**Sent:** 23/02/2021 5:08:32 PM  
**Subject:** DA2021-0060 Response to 10 Taminga St  
**Attachments:** 210223 DA2021-0060 Response to 10 Taminga St from 11.pdf;

**Re: 10 Taminga Street Bayview DA 2021/0060**  
**Response from 11 Taminga Street Bayview**

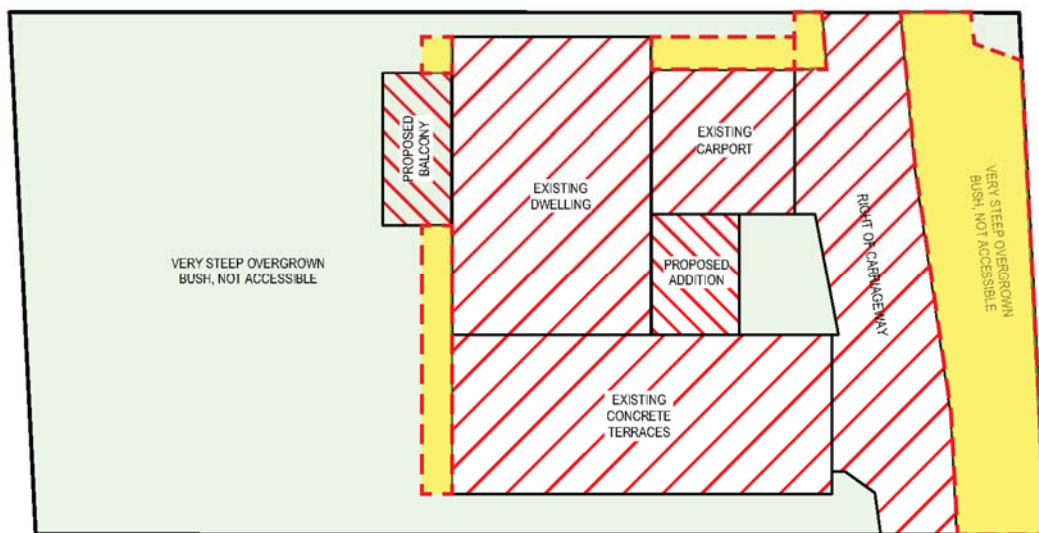
- The 5<sup>th</sup> storey of the proposed development will totally overlook interior windows and exterior spaces of our property, creating unwelcome privacy impacts, especially our front door, entry area, and outdoor sitting area (which is under construction).
- The 5<sup>th</sup> storey will be above all others in the surrounding area and includes a large outdoor space, so there is significant potential for noise impacts if any outdoor gatherings are to be

- The clearance of all canopy trees from number 10 will create significant local urban heat impacts. Our house includes passive design features and does not have air conditioning. As such, it is especially important for number 10 to make its contribution to the Bayview tree canopy because this could shade our property from the afternoon sun.

**Proposed East Elevation Annotated:** We request that privacy screens are included in the proposed development along the eastern edge of all stair and balcony spaces as shown above in yellow.

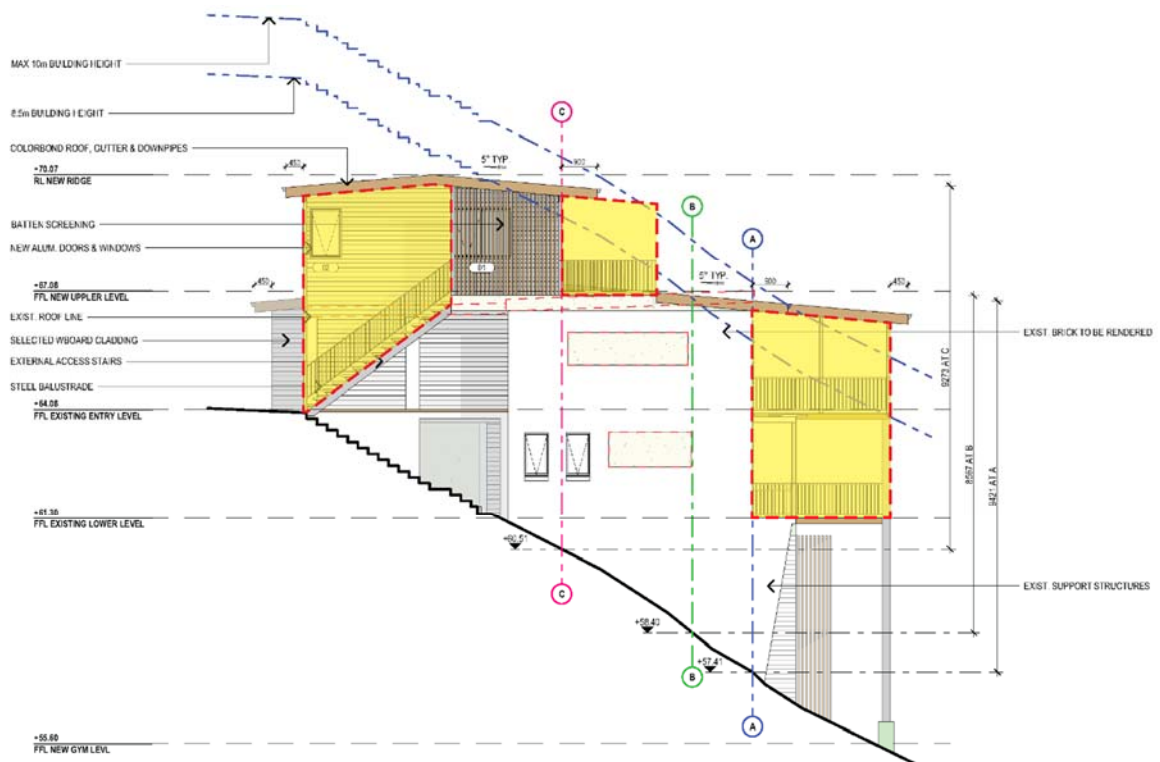
- When our house was built in 1978, the northern frontage of our balconies was drawn to align with the existing house at number 12. To reduce privacy impacts upon our neighbour, our house included a privacy wall on the balcony. Similarly, now that number 10 is proposing to align their new balconies with ours, we request that their design incorporates privacy screens along the eastern edge of the new balconies on all levels.

**Annotated Site Plan:** the proposed layout is likely to be incompatible with tree canopy planting, due to view conflict (yellow), proximity to the proposed dwelling (red), or already cleared and excavated land for an enlarged driveway (blue).

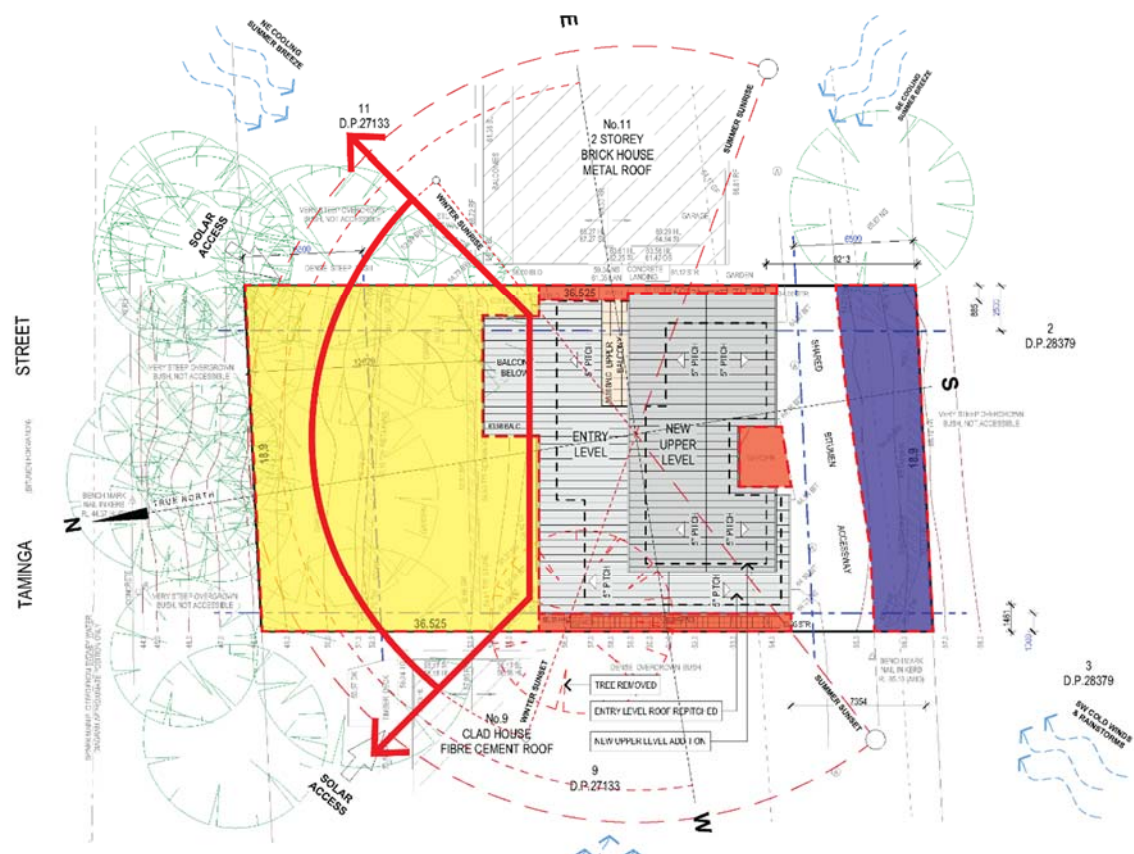
- As noted above, the proponents have already cleared mature canopy trees on their site, and the current development proposal suggests removing all remaining trees. Their proposed plan does not readily accommodate any new trees, due to lack of suitable space south of the house, and risk of view impact north of the house. Due to the extent of tree clearing that has occurred and has been proposed, we request that the proposal is updated to include a plan for at least the 1 required canopy tree to be planted where it is in a suitable location for the proponents. We wish to note that we do not mind if the tree (or trees) are planted in front of their house, as we would be happy for our view to look through these trees. Our property includes 8 native and mature canopy trees to our north, which are delightful features for their shade, flowers, bird life, and filtered views. No matter where the proposed tree is located, it is important that neighbours and Council have assurance that the requirements for a canopy tree for this site is realistic relative to the proposed plan. Also, if the proposed development is revised and approved by Council, then this canopy tree planting can more readily be verified in a future Council assessment of the completed development.

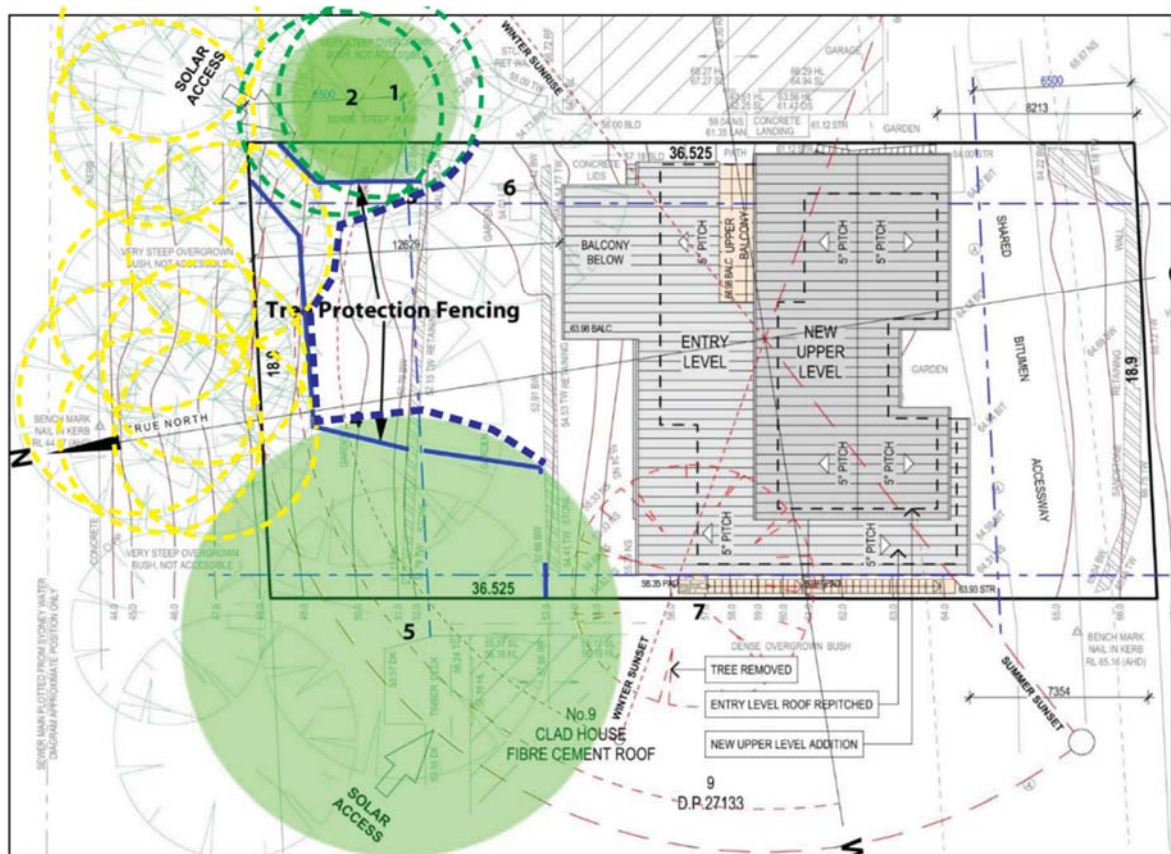
- The Arboriculture Recommendation Plan Figure C identifies trees 1 and 2 on our property for Tree Protection Fencing. These two trees are mature Cheese Trees in good condition. There are also more significant native trees on public land in Taminga Street to the immediate north of our property that have not been identified or assessed by the arboriculturalist. In the interest of maintaining the health of all these trees we request an enlarged TPZ that is at least twice the Structural Root Zone radius of each tree. It is suggested that the reduction in working space in the garden during the construction would likely not have a significant impact on the construction activities, as most of the building works are likely to occur at the entry level.

- Figure C identifies TPZ fencing with an access route onto the site from Taminga Street. This is due to the existing entrance pathway for number 10 overlapping over the corner of our property. While we don't mind this access route continuing in the short term for construction worker access from Taminga Street, this sensitive garden space isn't a viable pathway for the carriage of construction machinery or materials. We therefore request that during construction, only pedestrian access be permitted onto the site from Taminga Street. In the long term, if a new landscape plan is drawn for number 10, then this plan should consider the boundaries in the alignment of the future pathway.

**Annotated Arboricultural Plan:** We request enlarged TPZs around our trees (green dash / numbers 1 and 2) and the trees on public land (yellow dash), and for the Tree Protection Fencing area to be adjusted accordingly. Only pedestrian access should be permitted from Taminga Street during construction.
